INTERNATIONAL TRUCK AND ENGINE CORPORATION

Re: Draft Staff Report on Reducing California's Petroleum Dependence, Docket No. 01-SRPD-1

Revised Figure 3
Direct Net Benefits of Fuel Efficiency Options (With Light-Duty Diesel Assumptions Corrected)

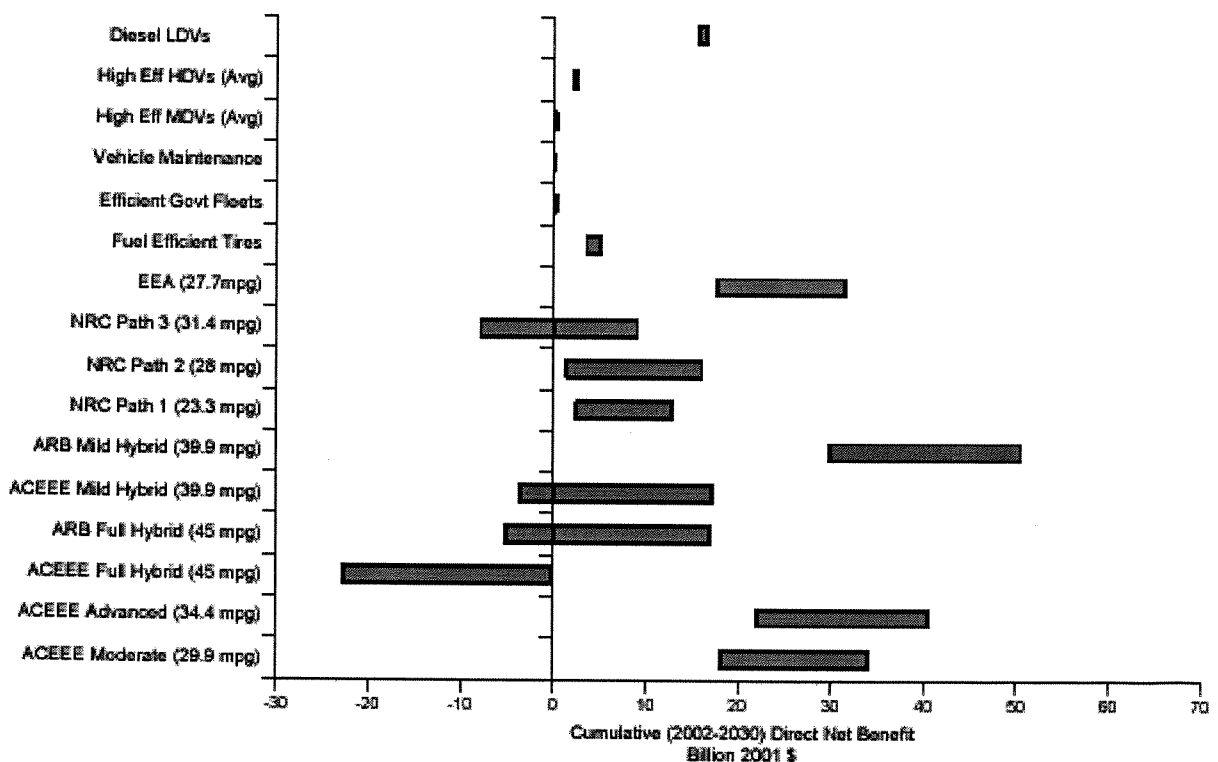
International nonetheless remains concerned that the direct net benefits calculated for light-duty diesel vehicles and reported in Figure 3 of the Executive Summary dramatically understate the actual benefits of this option and imply that other technologies, such as hybrid

electric drive vehicles, will yield significantly higher benefits. There are three core reasons for this understatement: (1) the Draft Staff Report assumes only 10% market penetration for diesel light-duty vehicles, but 100% market penetration for all other fuel efficiency options; (2) the Draft Staff Report significantly overstates diesel particulate matter (“PM”) emissions as compared to gasoline PM emissions, and simultaneously overstates the monetary health impacts of PM; and (3) the Draft Staff Report includes an error in the conversion of diesel fuel into gasoline fuel equivalents, thereby discounting the actual fuel efficiency gains from diesel (which provide both a monetary benefit and a reduction in greenhouse gas emissions). If these errors are corrected, diesel will be shown to have \$14.5 billion in direct net benefits, as illustrated below.

Market Penetration Assumptions. Figure 3 of the Executive Summary provides the direct net benefits of various fuel efficiency options. Significantly, *every option in Figure 3 except diesel is assumed to have a 100% market penetration – while diesel is assumed to have only a 10% market penetration.* In other words, for purposes of assessing direct net benefits, the Draft Staff Report assumes that any technology under consideration other than diesel, including

The differential market penetration assumptions in Figure 3 result in an “apples to oranges” comparison, which will be misleading to policymakers and is technically inaccurate. If equivalent market penetration rates were assumed, the benefits of all options other than diesel would be *one-tenth* of what they appear to be in Figure 3. Alternatively, the benefits of the diesel option would be ten-fold greater than what appears on Figure 3. This adjustment would more fairly reflect the relative net benefits of light-duty diesel as compared to other options and foster more balanced judgments about the most appropriate petroleum reduction policies to pursue.²

To allow for a reasoned comparison among the different petroleum reduction options, International strongly urges that Figure 3 of the Draft Staff Report be revised to assume the same market penetration rates for all technologies under consideration. At a bare minimum, if the Draft Staff Report is not revised in this manner, the header for Figure 3 should prominently and clearly highlight that ARB and CEC have assumed a 10% market penetration for diesel, but a 100% market penetration for all other options, as follows:

Implications for Direct Net Benefits of Diesel. International has done a rough re-calculation of the direct net benefit of light-duty diesel, once the above three issues are corrected. The calculations are provided in an Attachment to these comments. In brief, after correcting for the above errors, the direct net benefits of diesel increase from \$0.81 billion to \$14.5 billion. Figure 3 of the Draft Staff Report should include this revised direct net benefit number.
